# Walsh Bay Arts Precinct

Modification Application  
Mod 7

February 2022

Figure 2: proposed eastern façade (Plan A-222, 24/01/22)

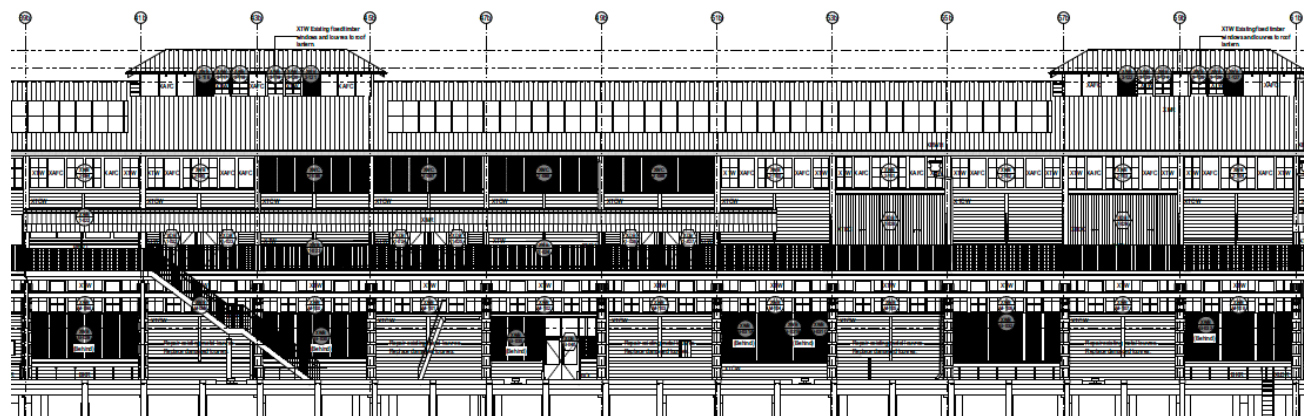
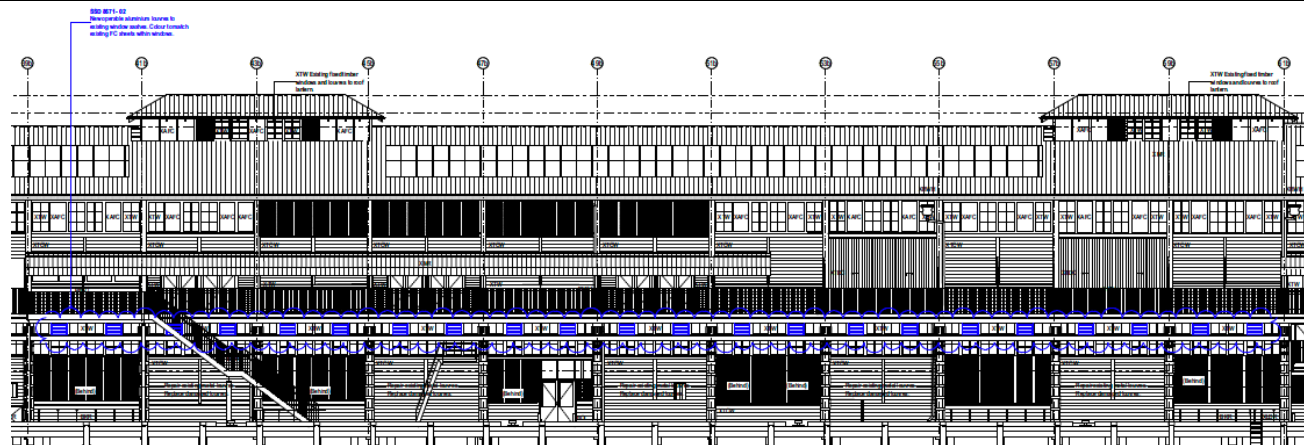
To maintain thermal comfort for occupants of the studios it is proposed to install louvres above existing windows along the western façade. These louvres will assist in exhausting warm air from the studios.

The proposed louvres will assist with natural ventilation of Studios 1-4 and in maintaining occupant comfort. The 22 louvres will replace existing fibre cement (non-heritage) sheeting that is located on the upper sash of every 2<sup>nd</sup> and 5<sup>th</sup> window along the façade. The louvres will be aluminium and be painted to match the colour of the existing fibre cement sheeting.

Figure 2: proposed eastern façade (Plan A-222, 24/01/22)

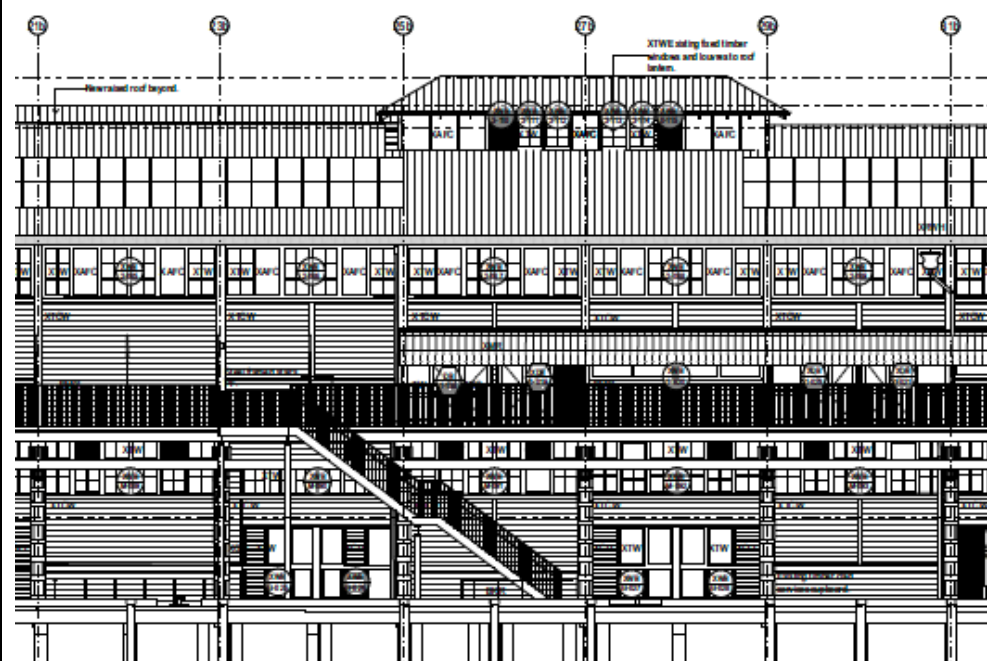
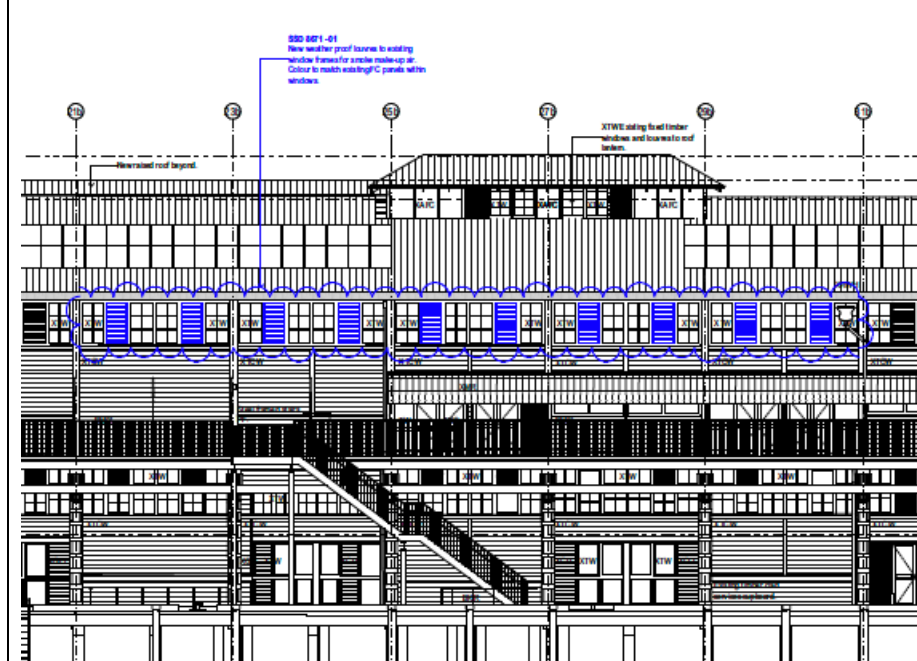
In order to ensure weather proofing of the Sydney Theatre Company tenancy, it is proposed to replace the louvres with new 'two-stage' louvres that will prevent the ingress of water. Due to the design of the two stage louvres, additional venting will be required which is proposed to be via the installation of an additional 10 louvres to replace existing fibre cement sheeting.

The proposed louvres will assist with weather protection of the space whilst maintaining requirements for smoke exhaust. The 10 louvres will replace existing fibre cement (non-heritage) sheeting currently fitted to window frames along the façade. The louvres will be aluminium and be painted to match the colour of the existing fibre cement sheeting.
